The Glitch

Overview: A solar combisystem is being planned to provide a portion of the space heating and domestic hot water needs of a new “Eco” house being constructed in Vermont. The house will have plenty of south-facing windows to help warm it on sunny winter days.

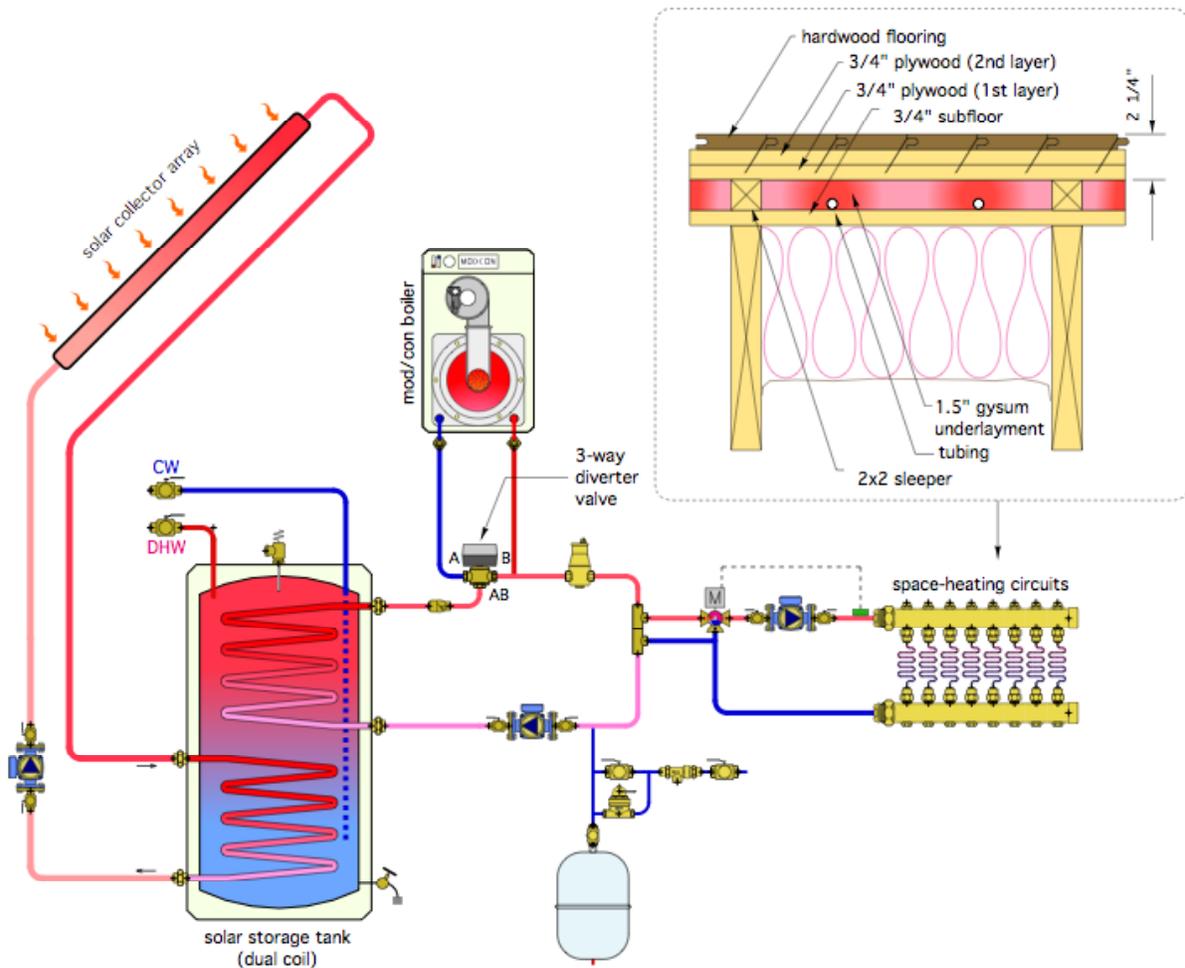
The owner loves the idea of warm floors, but also wants nail-down hardwood flooring. The flooring contractor plans to install that floor as shown in the cross-section below (because he saw this detail in a major home building publication).

Exercise: Look over the schematic and the planned floor installation detail. Do you see any problems lying in wait?

The flooring installer doesn't want any issues with keeping that floor flat, so he specifies two overlapping layers of 3/4" plywood for the underlayment. This adds considerable thermal resistance between the water in the tubes and the top surface of the floor. This significantly increases supply water temperature, especially at design load conditions.

Although such a floor would probably operate adequately at design load conditions if supplied with water in the 160 °F range, such temperatures are quite presumptuous for a solar system using flat plate collectors during a cold Vermont winter. The solar energy contribution to space heating in such a system will be very limited.

The original piping schematic is also missing several essential components in the solar collector circuit. It also lacks an anti-scald tempering valve on the domestic hot water piping and purging valves in the space heating system. These components are identified in red on the Fix drawing.

The Fix

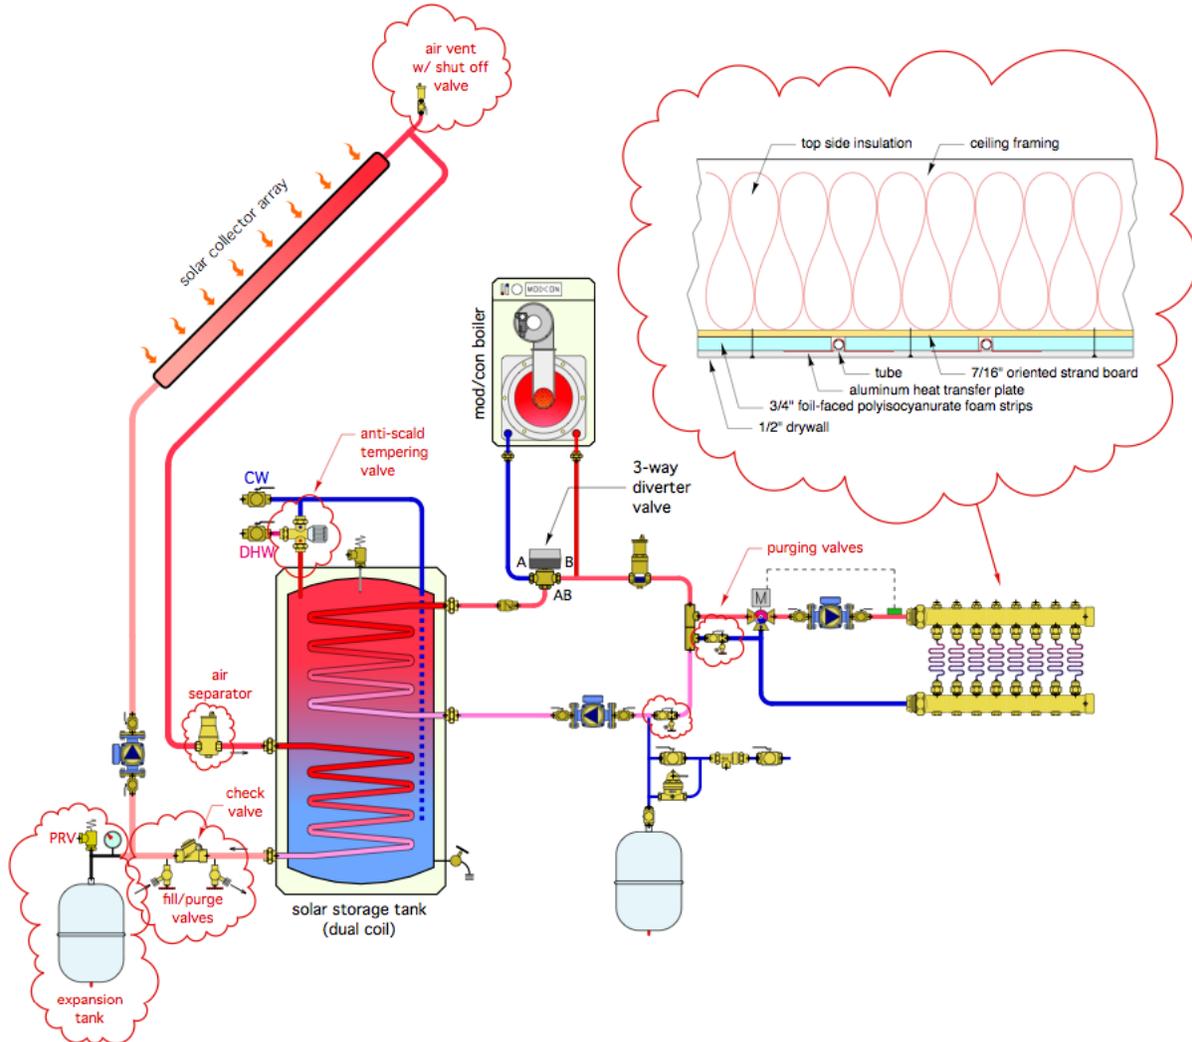
The flooring installation detail shown did appear in a major building publication. It's the result of asking a flooring specialist (rather than a heating specialist) how the flooring should be installed over a radiant panel.

A low mass radiant panel (such as the ceiling panel shown in the Fix drawing) would be a far better choice. Its low thermal mass responds quickly to internal heat gains, which are likely in a house with lots of south-facing windows. This panel also has much lower thermal resistance than the construction shown in the Glitch drawing, and thus will operate at lower supply water temperatures. This means higher collector efficiency and greater energy yield from the solar subsystem.
